Tipping test on the style of 0674xxx console to comply with NEW ASTM F-2057-23 regulation

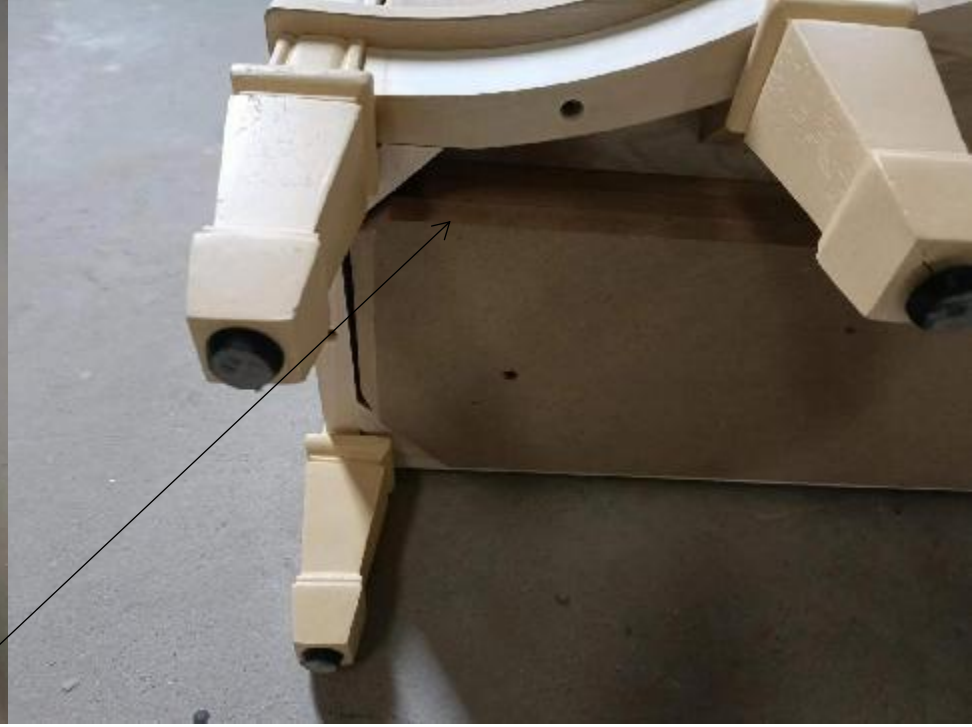
Increasing the thickness of back panel from 5mm to
18mm fiberboard, also to remedy tipping issue.

Added 3pcs of 18mm fiberboard to increase 25 KGS counterweight to avoid tipping issue.
